ADDENDUM NO. 4

PROJECT NO. 950464 CONTRACT NO. 950464-LF-2022-21

Project Name: Batchelor Hall Building Systems Renewal

SCHEDULE

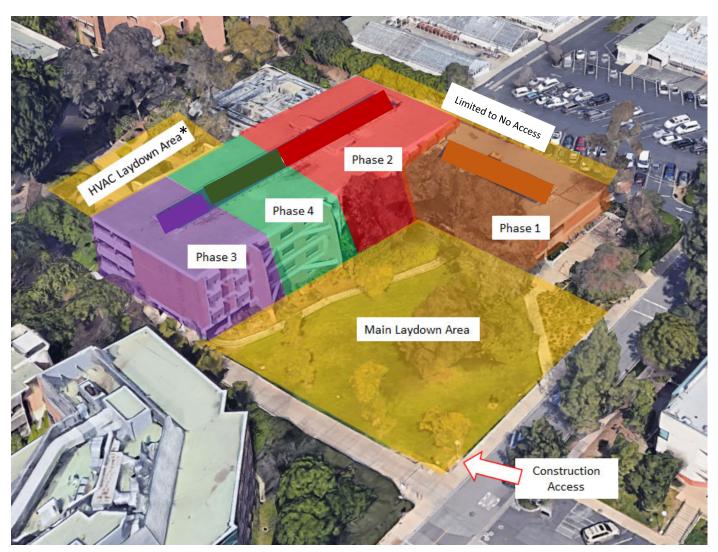
Answer: As noted in specification section 23 31 13-2.4-4.a, all Laboratory and Fume Hood Exhaust Ductwork to be 316 Stainless Steel. On the typical floor plans, the grey shading does not indicate any change of material in the
	ductwork. Yes. Materials are listed on plan Legend and in specifications.
1-152R1	Question: Can you provide the schedule slide from the prebid meeting?

Answer: Please see slide provided in this Addendum. Remember that it is up to the contractor to validate the estimated timelines shown in the slide. Also see RFI 1-60.
	*slides were inadvertently not included in Addendum 2 as stated, including here and noting under Information Available to Bidders. Please also note that the phasing slide was updated to reflect what is believed as the current plan to be validated by contractor.
